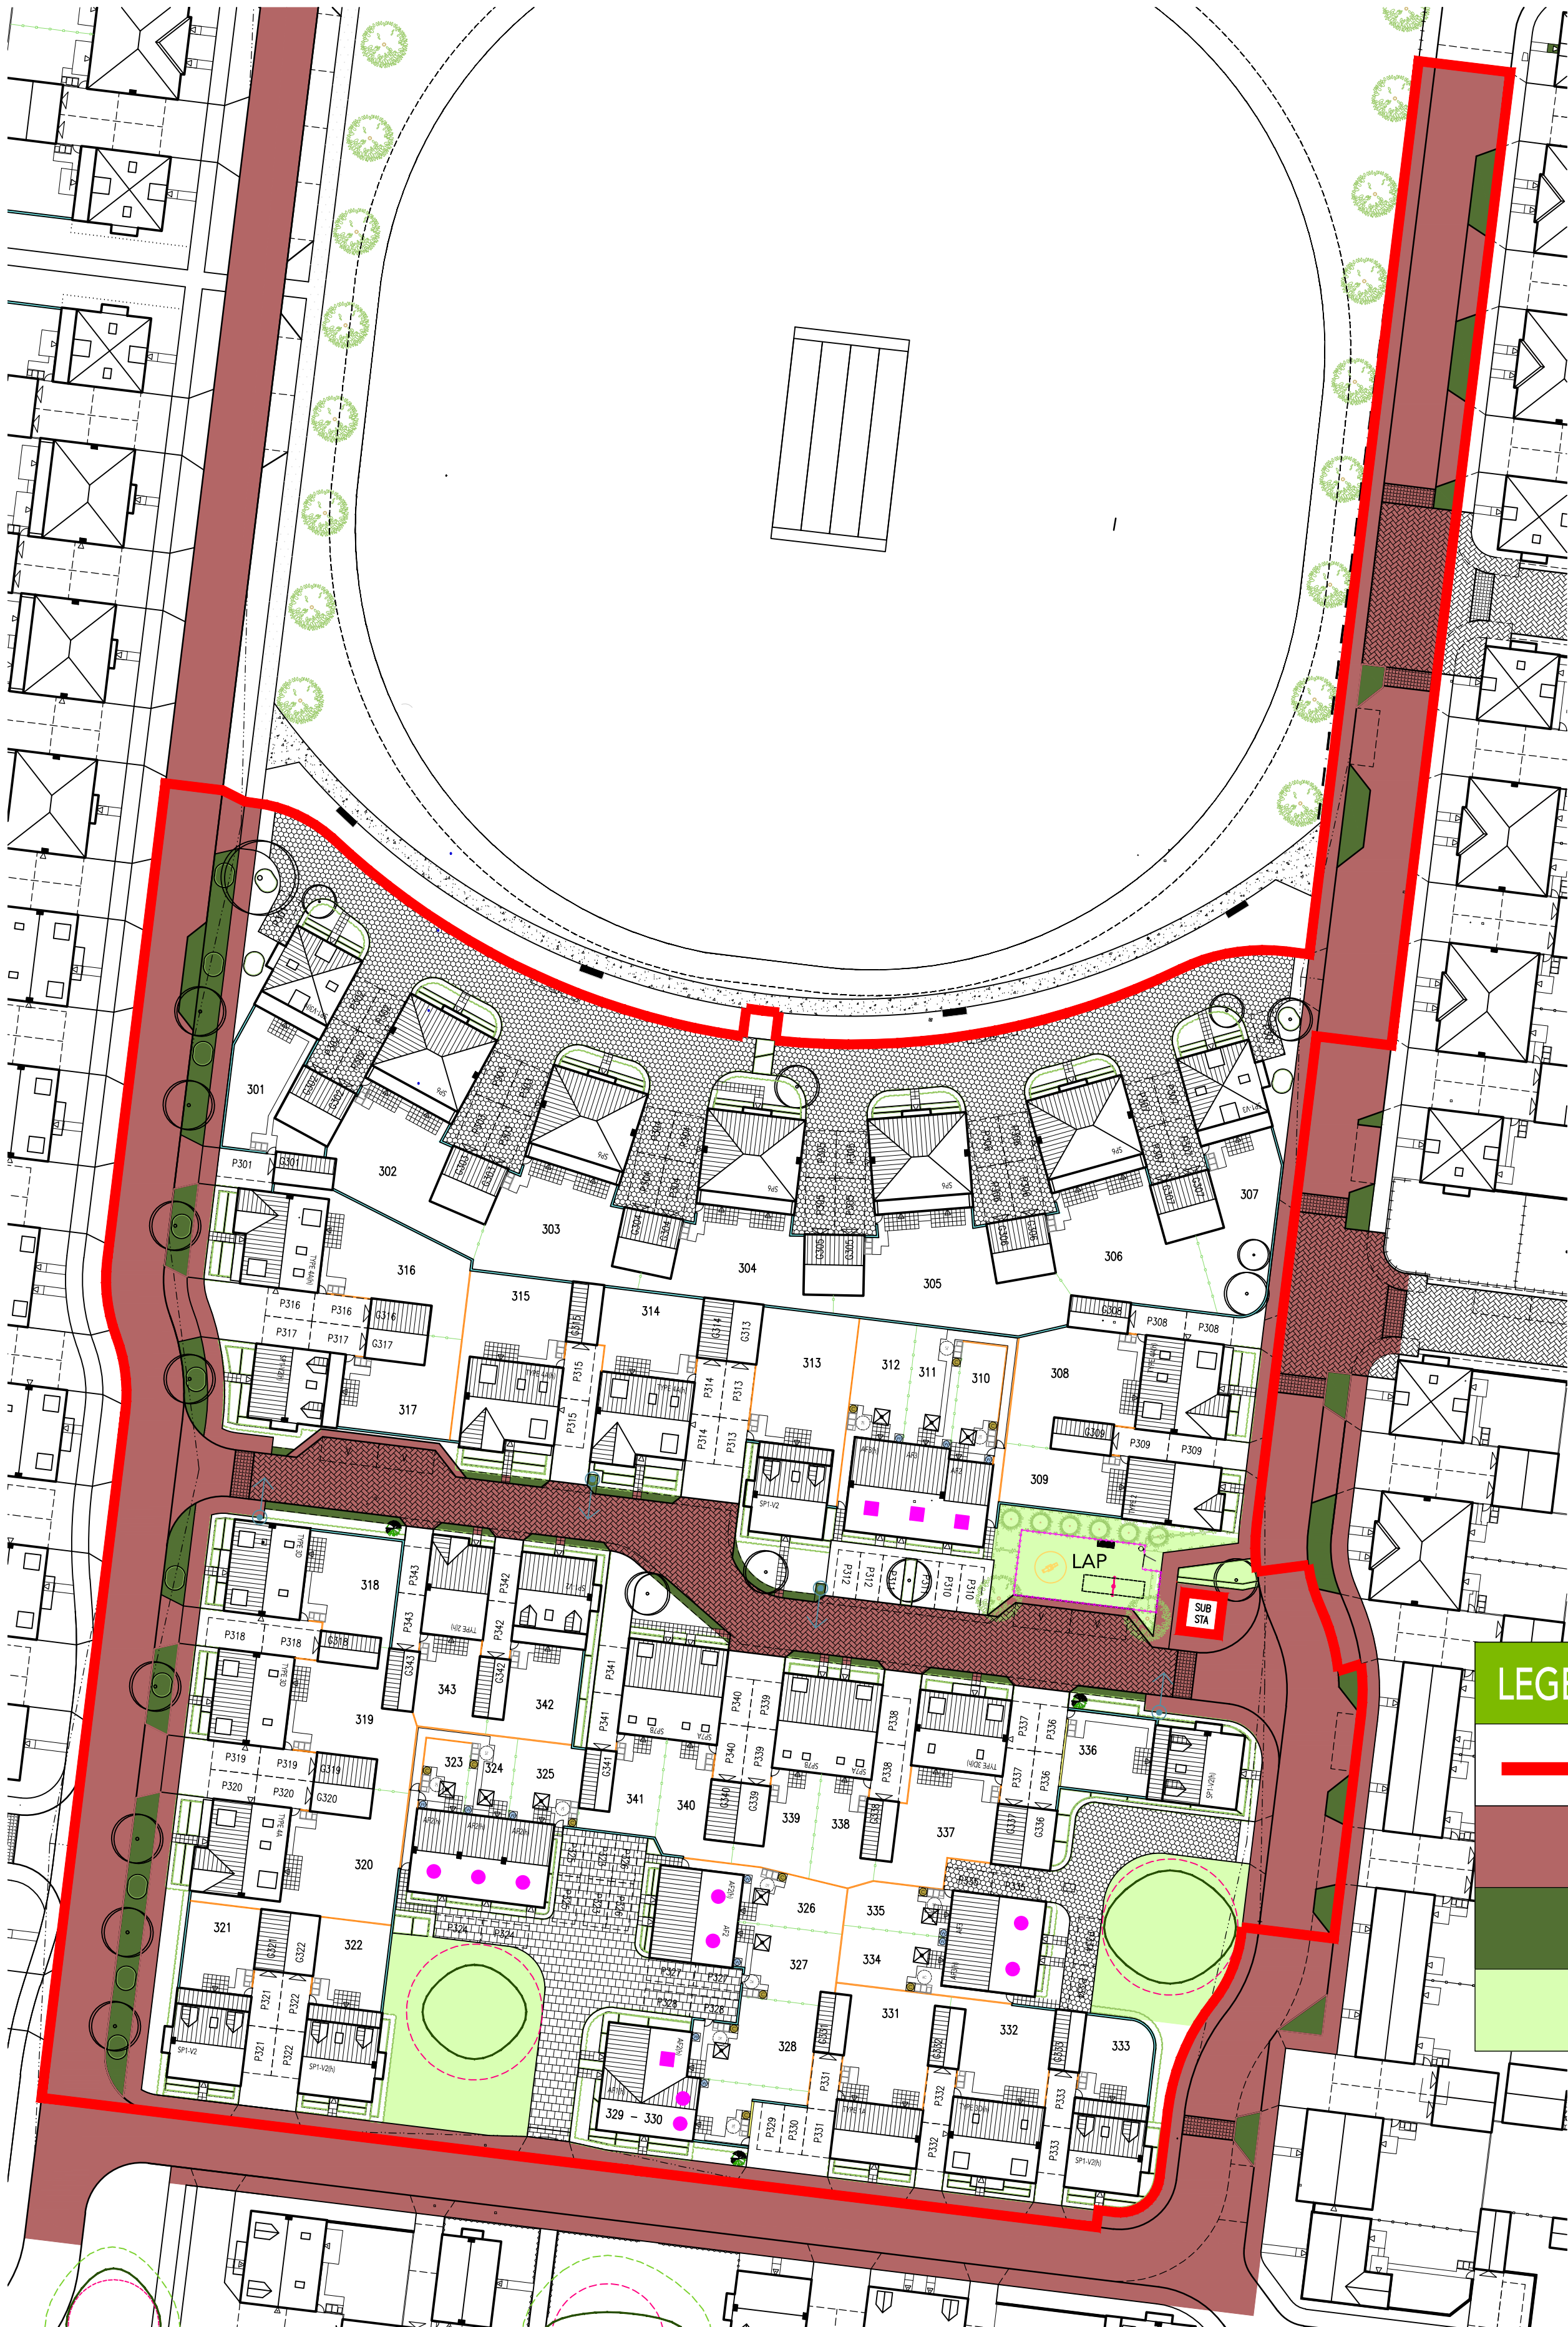
- A. 2015-12-03. Visibility splays added to junctions, landscaping and areas of adoptable highway and verges updated. DW
- B. 2016-01-12. Patio length updated for Type 1A, Type 1A-SA, Type 2, SP1, Type 3D, Type 4A & SP6 housetypes as per client request. SO

- C. 2016-02-26. Buildouts repositioned and on-street parking spaces amended along the road North East of the site. Area of adoptable highway and verges updated to suit. PVA

- D. 2016-03-22. Amended to suit revised Planning Layout. DJE
- E. 2016-04-19. Amended to suit revised Planning Layout. DJE
- F. 2016-05-10. Hard-standing around the sub-station and Type 3D footprint amended. MED

- G. 2016-07-15. LAP repositioned at Local Authority request. MED
- H. 2016-12-21. Bollard in front of plot 304 removed and replaced with a landscaped strip. MED

- I. 2017-03-17. Single garages increased in width to 3253mm and street lights and platforms added. AJA
- J. 2017-03-24. Rumble strips on private drives leading to gravel amended to tarmac/block paving, garages in plots 302 - 307 moved back to give 2m between garage and house and sheds removed. AJA

- K. 2017-06-14. Amended to suit revised Planning Layout 0521-Ph6-102-P. DJE
- L. 2018-01-26. LAP boundary adjusted. AJA
